Recall Service Bulletin

APPLIES TO: This Recall service bulletin applies to motorhome chassis, model year 2017, K2 and K3 models built between March 24, 2016 and August 31, 2016.

NHTSA/TC Id: 16V-776

CONDITION: Certain wires in the throttle circuit were not twisted which could result in a throttle setting above or below the commanded throttle setting/input.

FIG. 3-2

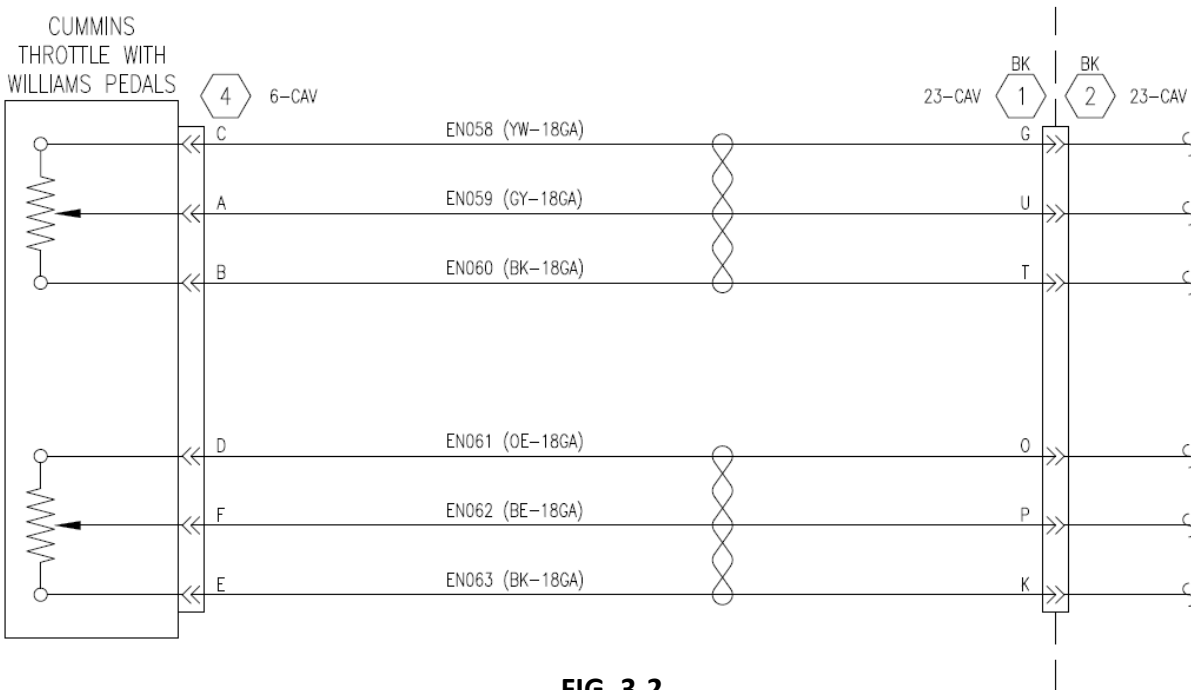
1. Identify and disconnect throttle pedal connector, Item **④** in FIG. 3-2, from throttle assembly. Pull back loom 12 inches over wiring terminated into throttle pedal connector. Verify wiring consists of 6 discreet wires (untwisted) then go to step 2. If wiring consists of 2 twisted triplets (refer to FIG. 3-2), replace loom over wiring and reconnect throttle pedal connector, Item **④**. No further action is required.

2. Pull back existing throttle pedal connector and stow/tape it back onto existing harness.
3. Connect new throttle pedal connector, Item **④**, of new 3995-GG5-001 overlay harness into throttle assembly. Refer to FIG. 3-2.

5. Locate and disconnect main chassis harness interconnect, Item **①**, from forward electrical compartment disconnect. Refer to FIG. 3-2
6. Using Deutsch contact removal tool, remove circuits from disconnected Item **①**, cavities O, P, K, G, U, and T. Refer to FIG. 3-1.

- Cut off contacts from removed circuits, individually heat shrink, and pull/tape back onto existing harness.
- Insert new circuits from new overlay harness into existing main chassis harness interconnect connector Item 1. Refer to FIG. 3-1. Each wire is tagged with a label depicting which cavity it belongs in. Refer to FIG. 3-2. Note that the wiring/pin out does not change.

9. Re-connect main chassis harness interconnect connector, Item , to firewall disconnect. Refer to FIG. 3-2.
10. Assure new overlay harness is secured to existing harness as required throughout its entire run. Tape back any extra length as required.
11. Using Cummins® INSITE™, verify that no fault codes are generated at key-up. Also verify that appropriate values are seen in regards to throttle pedal position.

FIG. 6-1

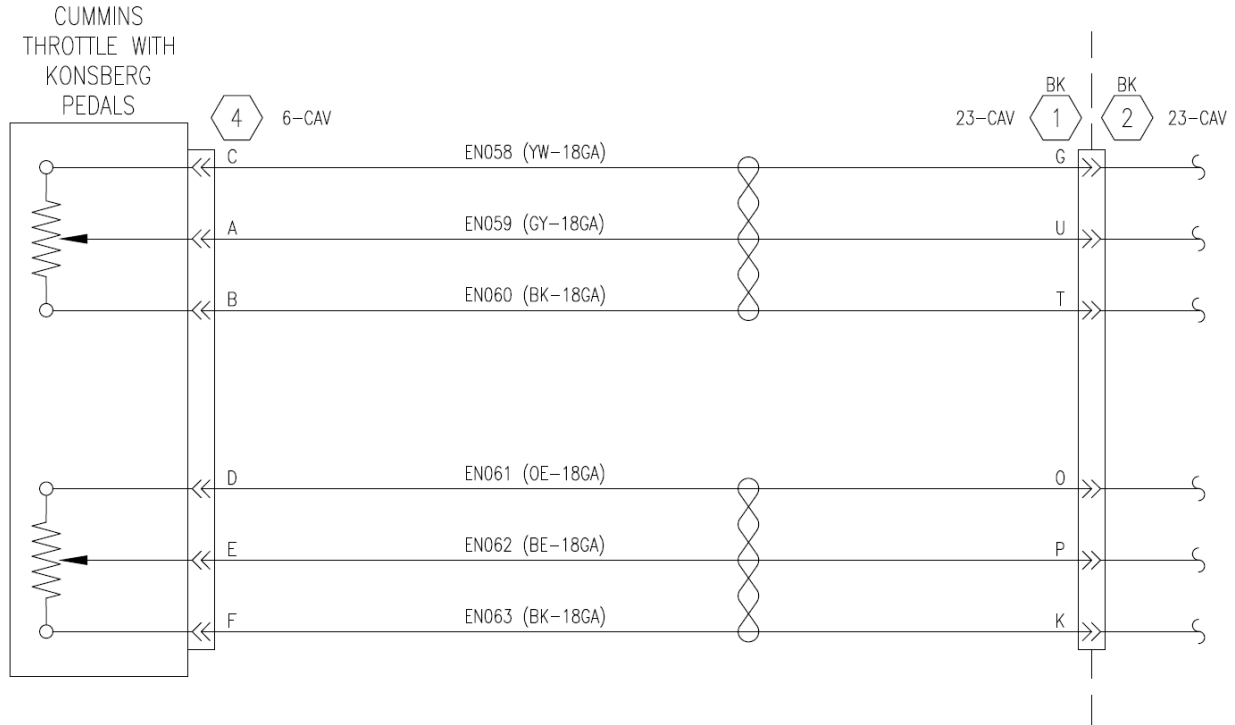
1. Identify and disconnect throttle pedal connector, Item **④** in FIG 6-1, from throttle assembly. Pull back loom 12 inches over wiring terminated into throttle pedal connector. Verify wiring consists of 6 discreet wires (untwisted) then go to step 2. If wiring consists of 2 twisted triplets (refer to FIG. 6-1), replace loom over wiring and reconnect throttle pedal connector, Item **④**. No further action is required.

2. Pull back existing throttle pedal connector and stow/tape it back onto existing harness.
3. Connect new throttle pedal connector, Item **④** , of new 3995-GG5-002 overlay harness into throttle assembly. Refer to FIG. 6-1.

4. Route and secure as necessary new 3995-GG5-002 overlay harness along existing harness to firewall disconnect located forward of driver's position.
5. Locate and disconnect main chassis harness interconnect, Item **①** , from firewall disconnect. Refer to FIG. 6-1.

- Insert new circuits from new overlay harness into existing main chassis harness interconnect connector Item **1** . Refer to FIG. 5-1. Each wire is tagged with a label depicting which cavity it belongs in. Refer to FIG. 6-1. Note that the wiring/pin out does not change.

- Re-connect main chassis harness interconnect connector, Item **1** , to firewall disconnect. Refer to FIG. 6-1.
- Assure new overlay harness is secured to existing harness as required throughout its entire run. Tape back any extra length as required.
- Using Cummins® INSITE™, verify that no fault codes are generated at key-up. Also verify that appropriate values are seen in regards to throttle pedal position.

FIG. 8-1

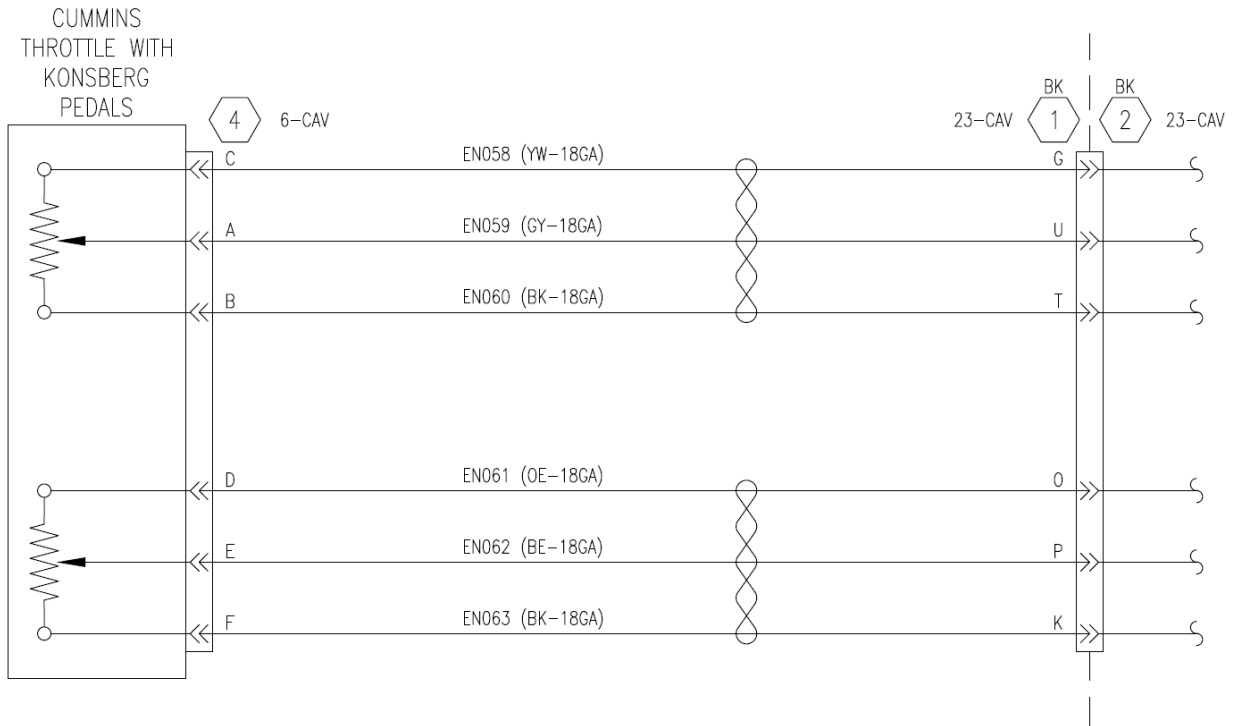
1. Identify and disconnect throttle pedal connector, Item ④ in FIG. 8-1, from throttle assembly. Pull back loom 12 inches over wiring terminated into throttle pedal connector. Verify wiring consists of 6 discreet wires (untwisted) then go to step 2. If wiring consists of 2 twisted triplets (refer to FIG. 8-1), replace loom over wiring and reconnect throttle pedal connector, Item ④. No further action is required.

2. Pull back existing throttle pedal connector and stow/tape it back onto existing harness.
3. Connect new throttle pedal connector, Item ④, of new 3995-GG5-002 overlay harness into throttle assembly. Refer to FIG. 8-1.

5. Locate and disconnect main chassis harness interconnect, Item ①, from forward electrical compartment disconnect. Refer to FIG. 8-1.
6. Using Deutsch contact removal tool, remove circuits from disconnected Item ① cavities O, P, K, G, U, and T. Refer to FIG. 7-1.

8. Insert new circuits from new overlay harness into existing main chassis harness interconnect connector Item **1** . Refer to FIG. 7-1. Each wire is tagged with a label depicting which cavity it belongs in. Refer to FIG. 8-1. Note that the wiring/pin out does not change.

9. Re-connect main chassis harness interconnect connector, Item **1** , to forward electrical compartment disconnect. Refer to FIG. 8-1.
10. Assure new overlay harness is secured to existing harness as required throughout its entire run. Tape back any extra length as required.
11. Using Cummins® INSITE™, verify that no fault codes are generated at key-up. Also verify that appropriate values are seen in regards to throttle pedal position.
